**White Salmon Planning Commission Meeting  
A G E N D A  
October 09, 2024 – 5:30 PM  
119 NE Church Ave and Zoom Teleconference**

Cherry Hill Estates Preliminary  
Plat

WS-SUB-2024.001 and WS-SEPA-2024.001  
Applicants: Alex Pedroza of HRK Engineering &  
Field Services, representing Cherry Hill NW, LLC  
and Cameron Curtis of Legacy Development  
Group

**STAFF RECOMMENDATION**  
September 25, 2024

SHEET NO. **2** OF 4

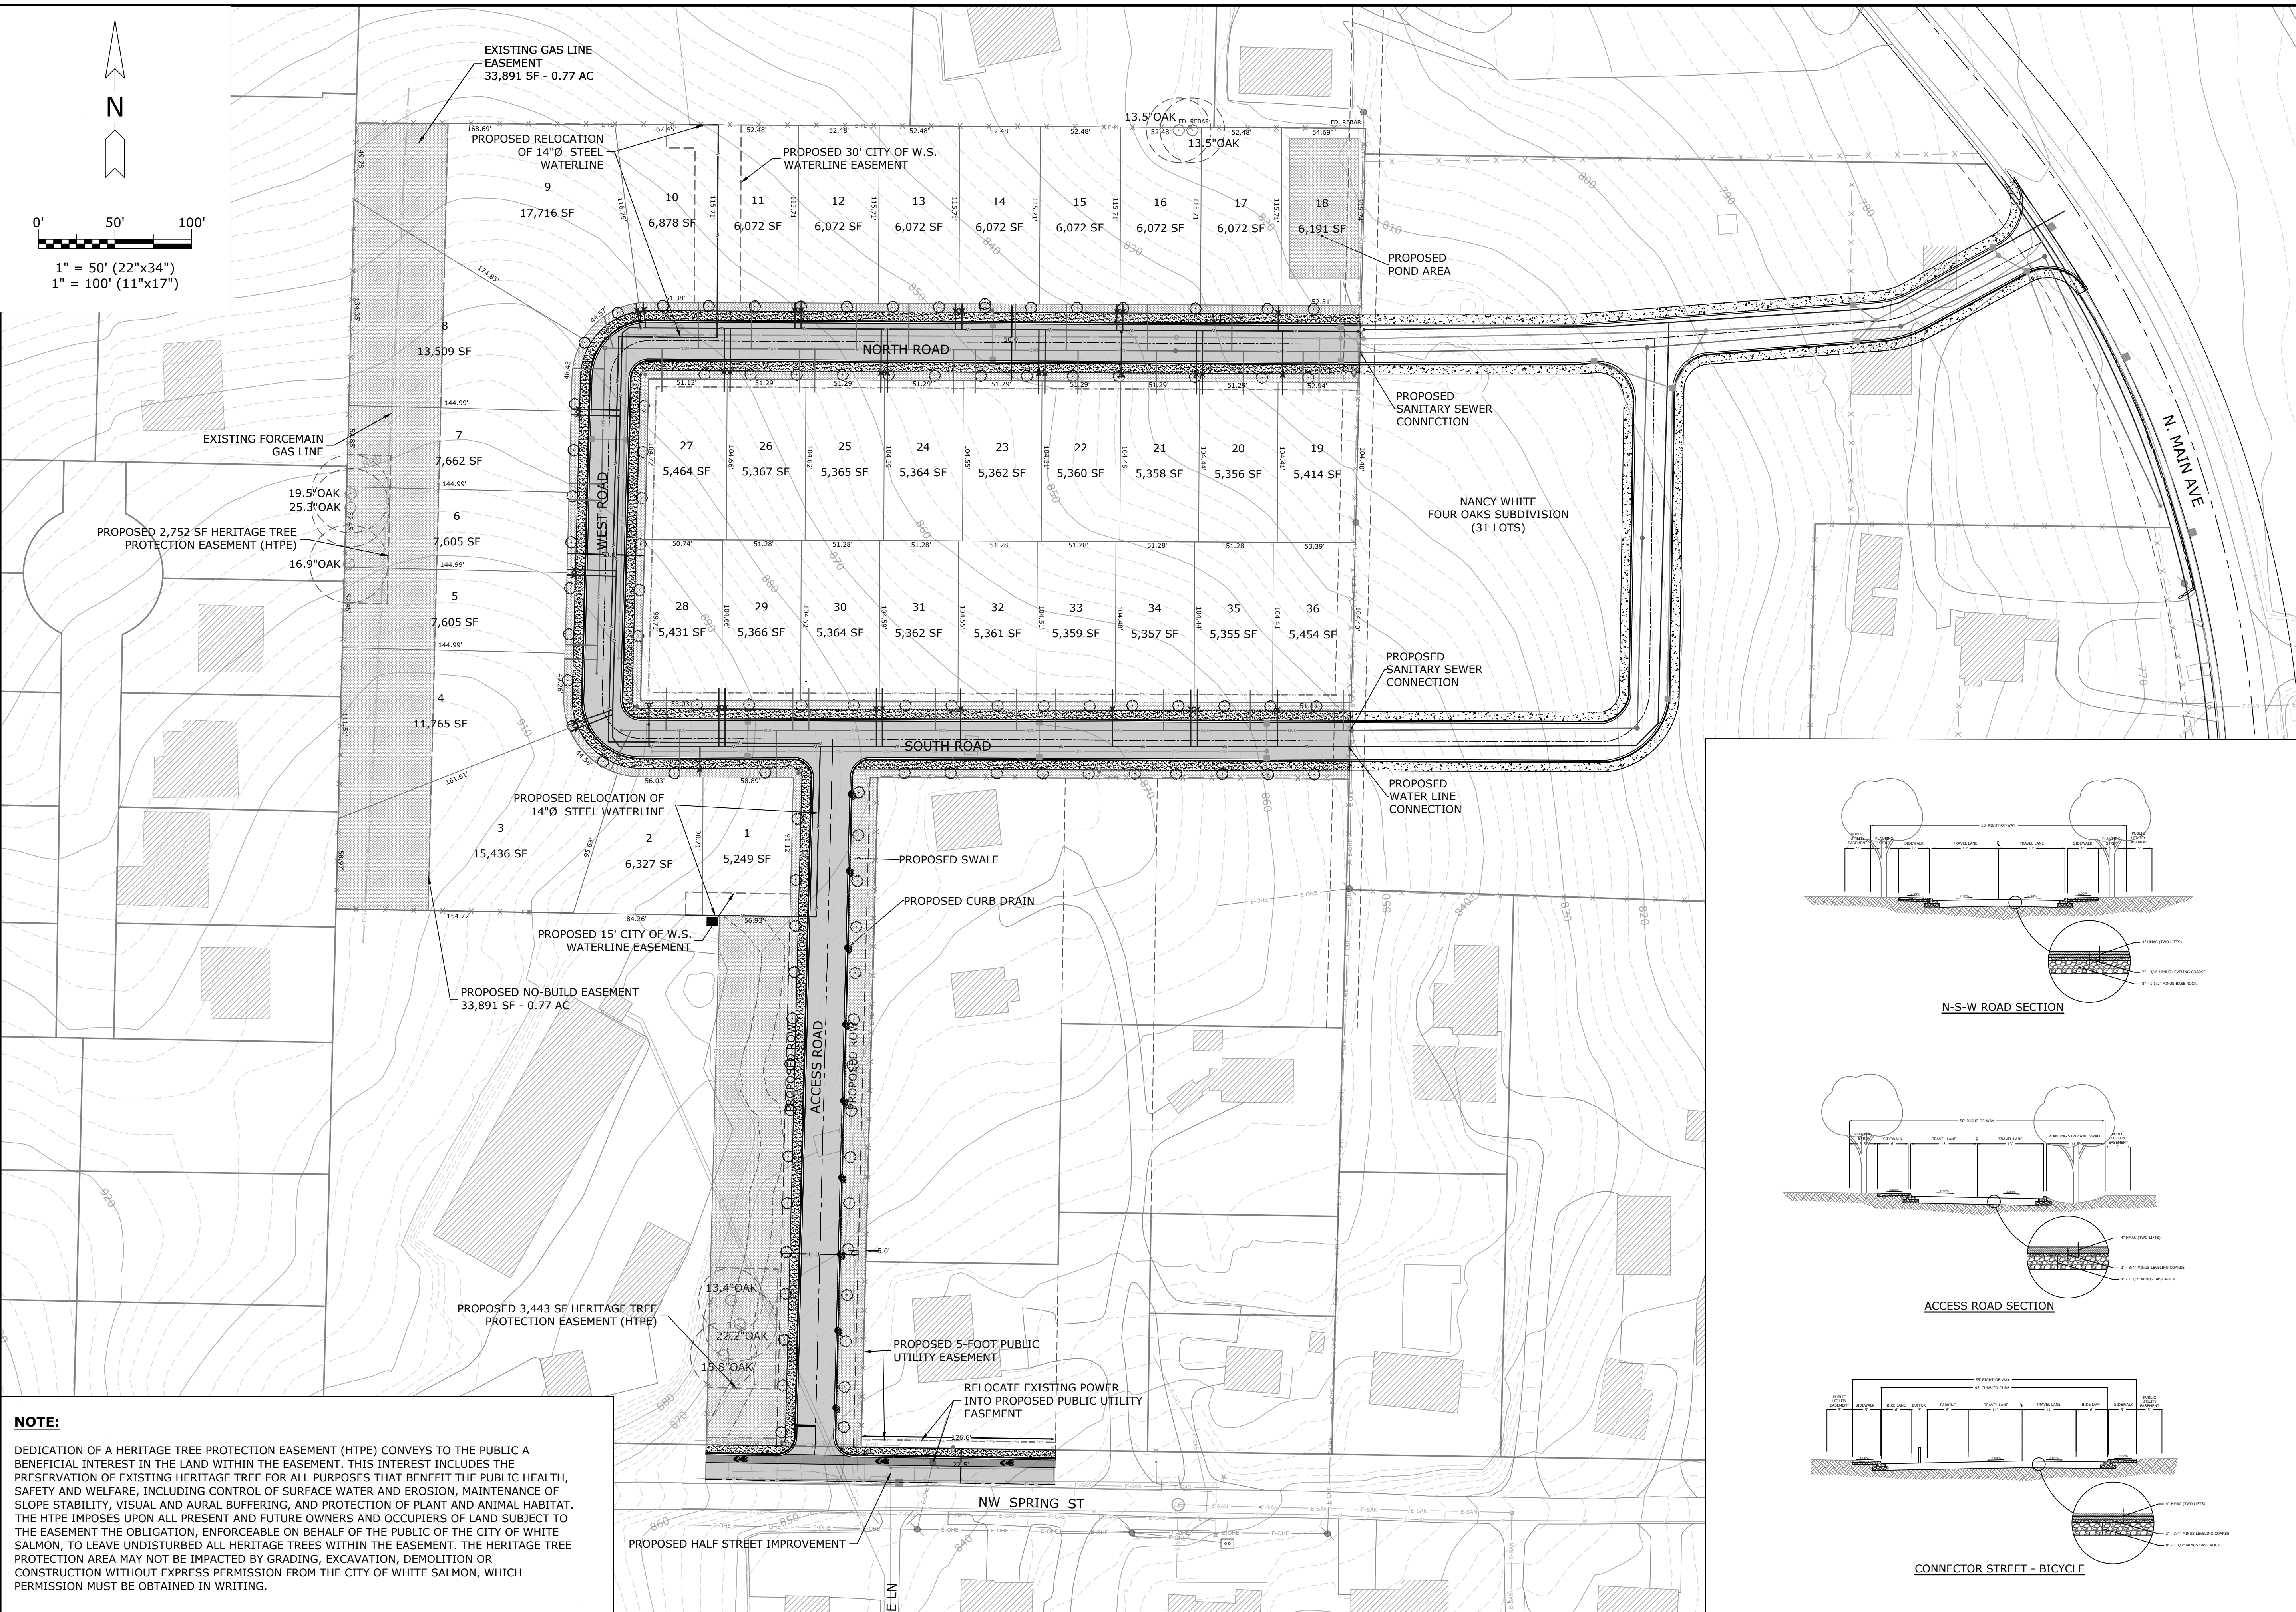
**FINDING** – Upon further review of site critical area constraints, a regulated steep slope exists along the southwestern boundary of the site, as mapped on sheet 2 of Exhibit 3. Per review of the project

SHEET NAME  
 SITE PLAN  
 SHEET NO.  
 3 OF 4

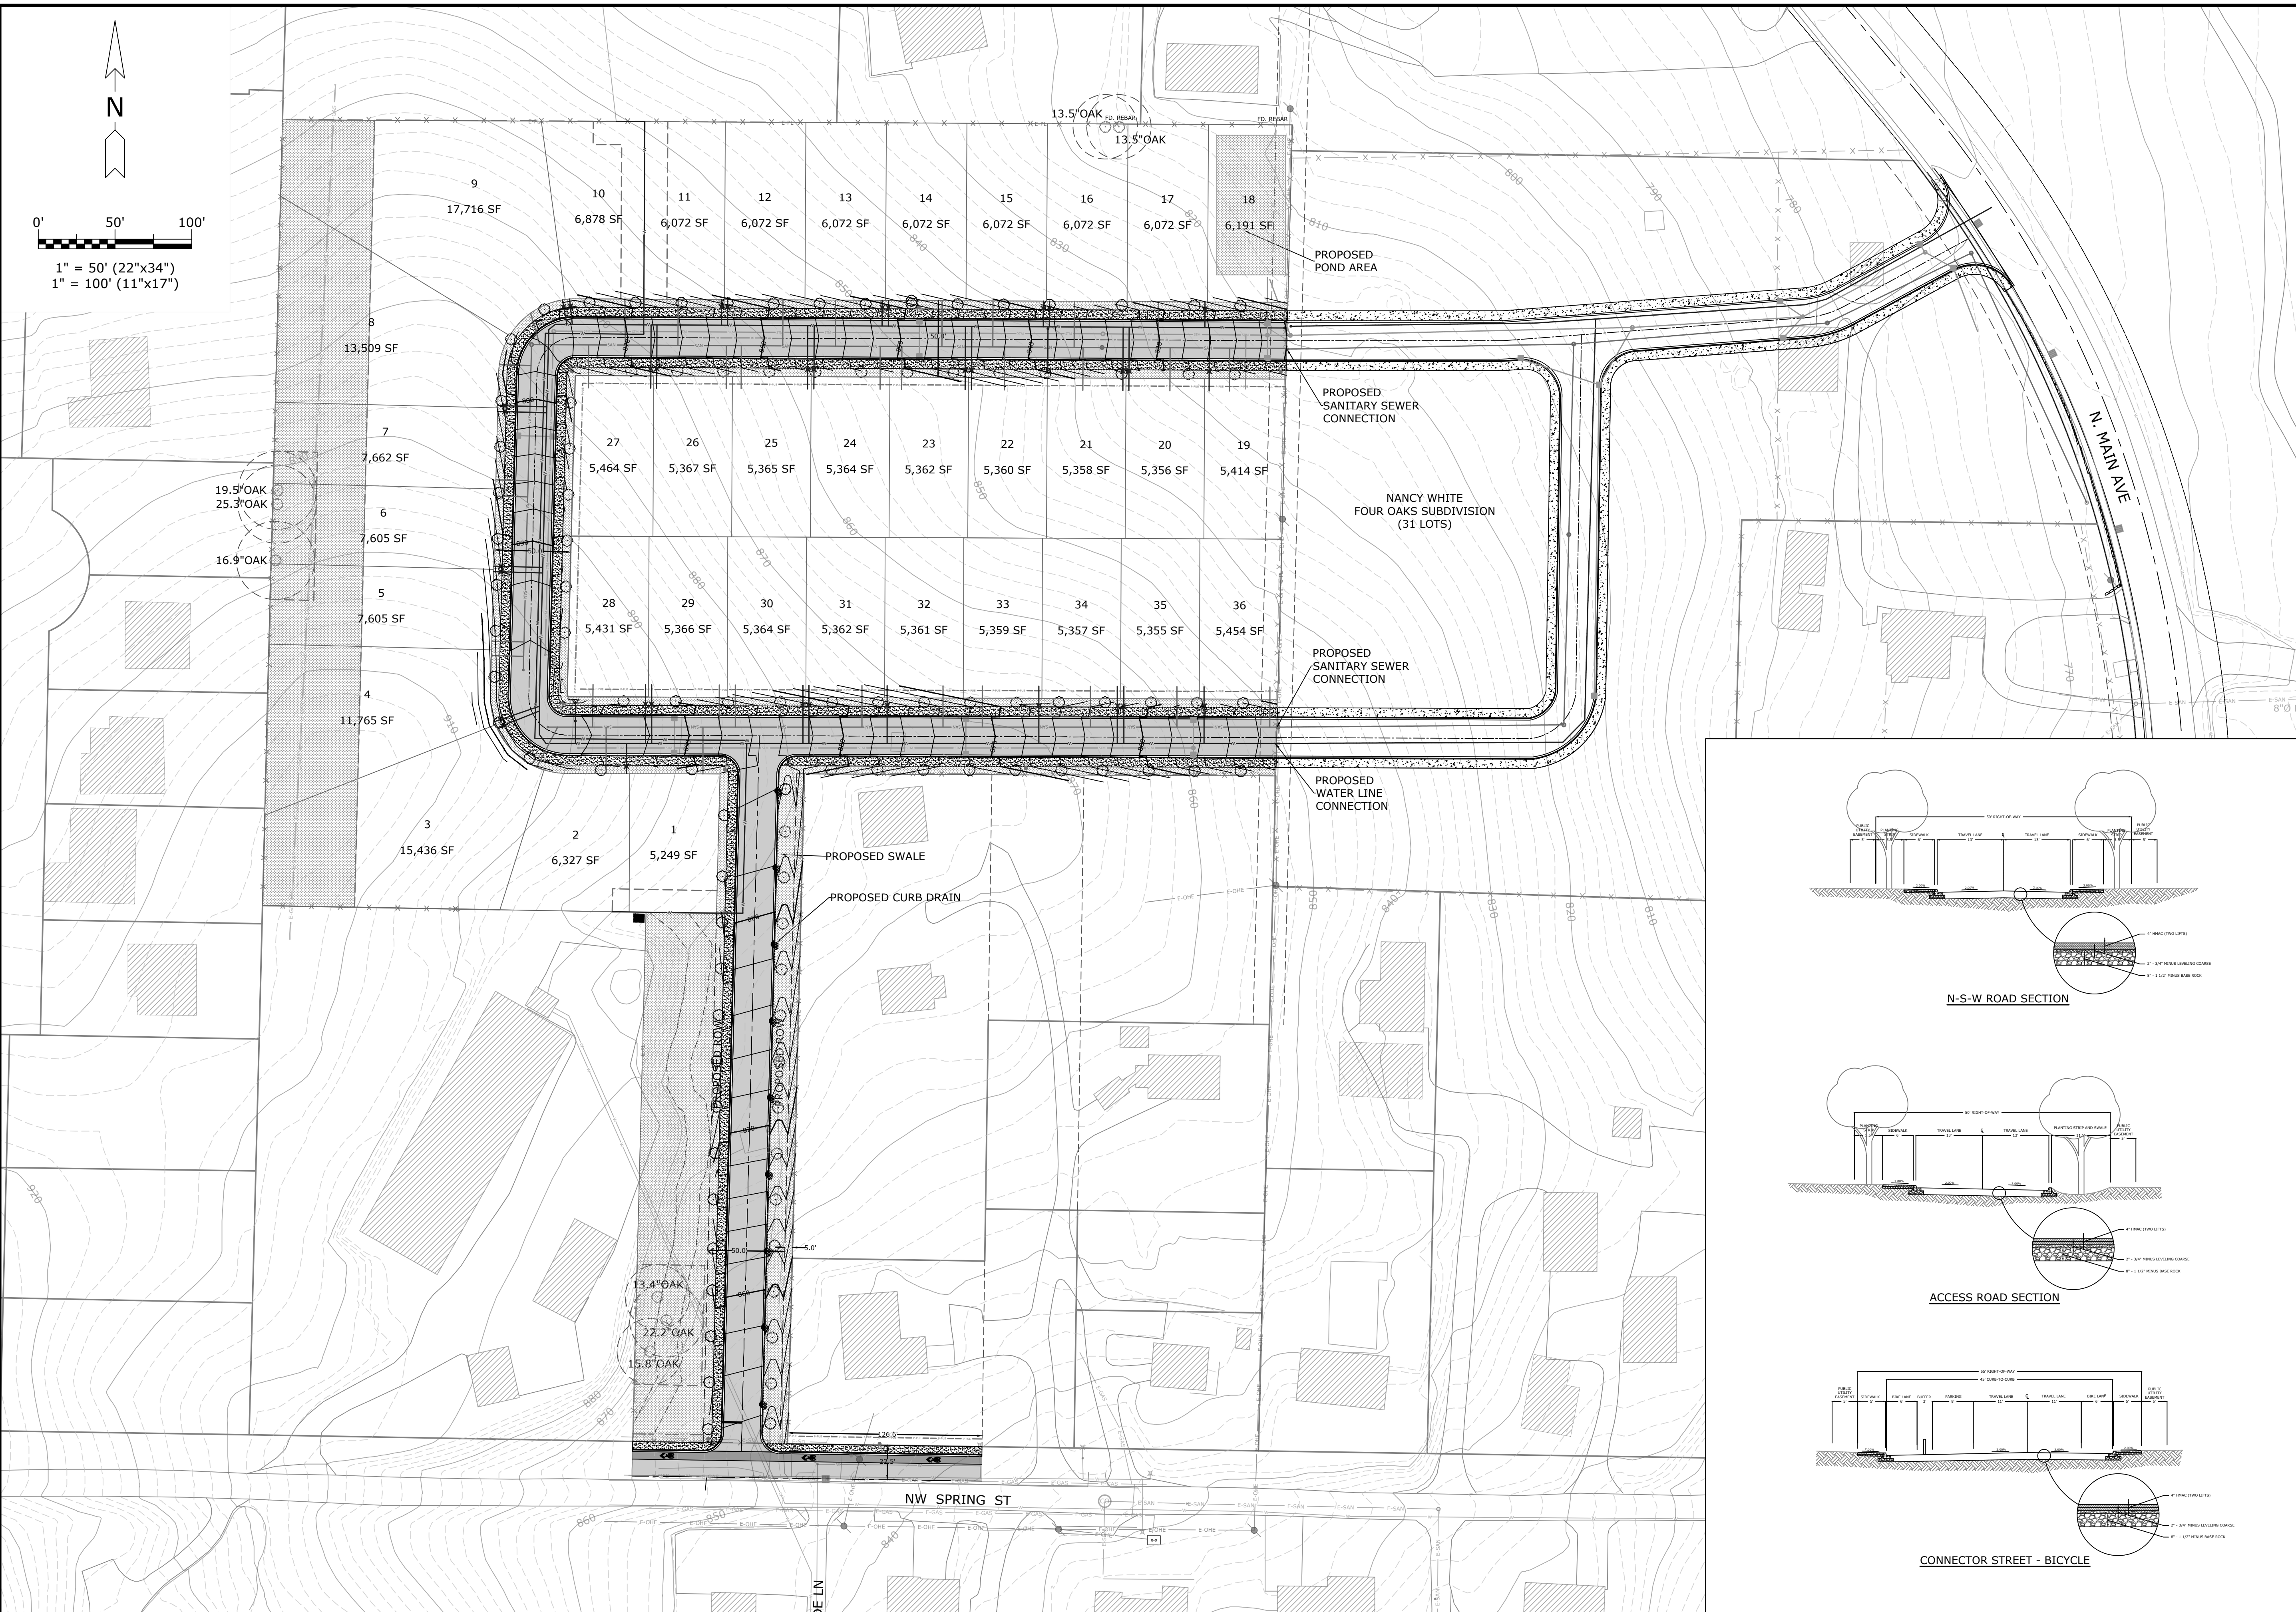
2. Please show the proposed water line easement benefitting the City, bordering proposed lots 8, 9 and 18, as shown on sheet 3 of the site plan.
3. *Please provide an arborist report to evaluate the presence or absence of heritage trees, as defined and regulated under WSMC 18.10.317. If found, please provide an assessment of protection needs on-site.*

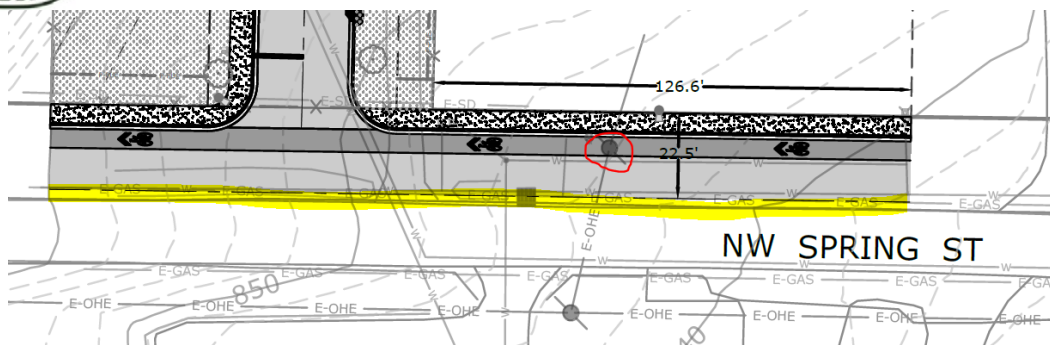
3. A full half street improvement on NW Spring Street is required, since there is no road base, and could otherwise create failures in the sidewalk in curb (see image below).

Figure 3 Typical Cross-Section for Connector Street on the Bicycle Network

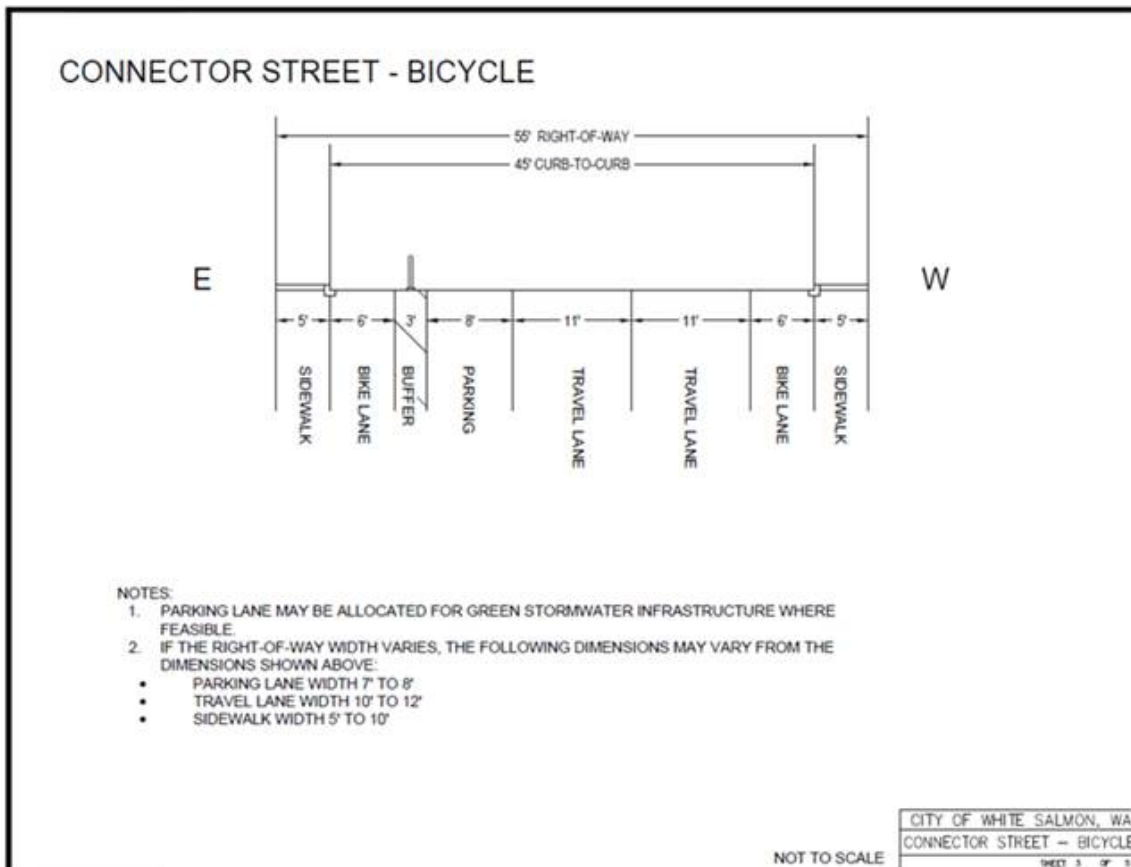
**FINDING:** A Connector Street on the Bicycle Network includes a 11’ travel lane, 6’ bike lane, and 5’ sidewalk, per Figure 26 of the TSP (as referenced as Figure 3 in the Street Design Guidelines within Exhibit 12b).

Note, As shown in the attached Appendix C: Project List and Maps, NW Spring Street is a high-priority project for pedestrian and bike improvements. The City is currently applying for state funding to construct these improvements. If the City receives funding and constructs these improvements on the north side of NW Spring Street, the City may elect to waive this requirement. Please see the below cross-section from the City's TSP "Lite":
